Facelift for Inspection Pipes

Modification of all inspection pipes with round opening

previous version

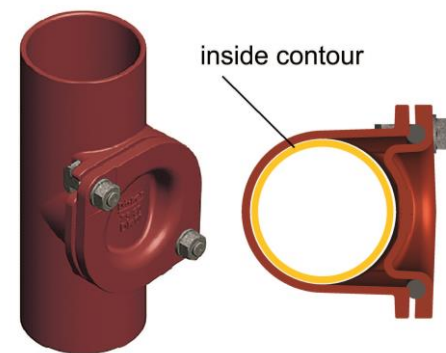
So far, the round inspection pipes have had completely circular covers, which were flat on the outside. Seen from the inside, the inspection pipe formed a depression in the wall of the down pipe – in accordance with the standards and proven over decades.

However, even proven products can be optimised. At individual customers' suggestion, Düker modified the cover shape so the inside contour of the pipeline is as smooth as possible. Now it is completely impossible e.g. for a smartphone that fell into the toilet to get caught here and to cause an obstruction. At the same time the smooth inside contour can further optimise acoustic protection.

The sealing is now neatly chambered. This ensures the necessary tensioning of the sealing without exceeding its elasticity limits – for higher performance and life expectancy of the sealing and guaranteed leak tightness even at higher pressure rates.

From December 2016, the production of Düker inspection pipes with round opening of all diameters and coatings will be changed to the new version. This applies to standard inspection pipes, but also to all bends and branches with round inspection openings.

If the cover of an "old" inspection pipe needs to be replaced, the new cover cannot be used!

Therefore, covers and sealings for the "old" inspection pipes with round opening will still be available as spare parts. Please use the following item numbers for your orders:
